Colin Field  
Town Planning Manager  
Temple Point, Redcliffe Way  
Bristol  
BS1 6NL

**Application for Prior Approval – Part 18 of GPDO at Oxford Railway Station  
21/02007/PA18  
Response to Environment Agency letter dated 1 November 2021**

Figure B 3: 1% AEP event +35%CC water level difference map

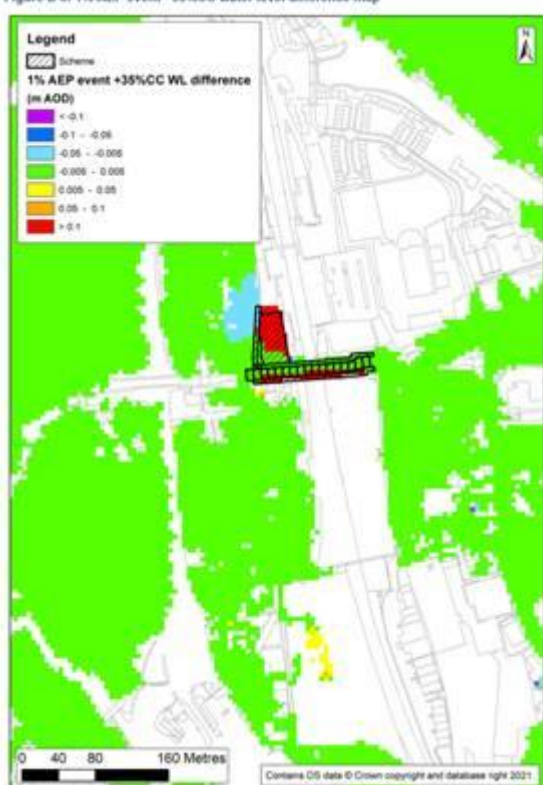
- The maximum water level difference at the Osney Cemetery between baseline and scheme is adverse for the 1 % AEP + 35 % Climate Change, as well as 0.1 % AEP event.

The 1 % AEP+41 % event would fall between these two events. Above that (for the 1 % AEP event +70 % Climate Change), maximum level difference becomes negligible.

As stated in the Flood Model Technical Report submitted to the EA and OCC (on 5 October by email), this is the consequence of a very limited volume of water pooling in a topographic depression area (the cemetery). Once the depression is full (as for the +70 % event) there is no more difference between baseline and with Scheme.

Network Rail believe that these changes in flood risk are of an acceptable level as:

- a. there are no properties at risk in the area of concern
- b. this happens for a small range of events
- c. the area of concern floods anyway, but the Scheme causes a slightly greater depth or slightly earlier onset
- We welcome the acknowledgement that *'the applicant is proposing to improve access along Botley Road for pedestrian and cycle users, which will provide a betterment over the existing access/egress arrangements with respect to flood hazards'*
